APPLICABILITY: All Models
SUBJECT: Tire Rotation Pattern

NUMBER: 05-37-07
DATE: 03/12/07

Tire Rotation Pattern for Non-Directional Tires

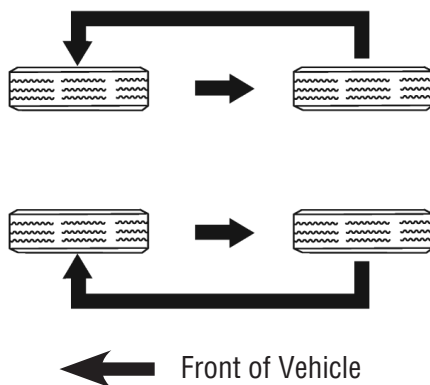
In an effort to further reduce uneven tire wear and prolong tire life, the tire rotation pattern has been changed for non-directional tires. To maximize the life of each tire and ensure that the tires wear uniformly, it is best to rotate the tires every 7,500 miles (12,000 km). Note: The tire rotation pattern for directional tires has not changed.
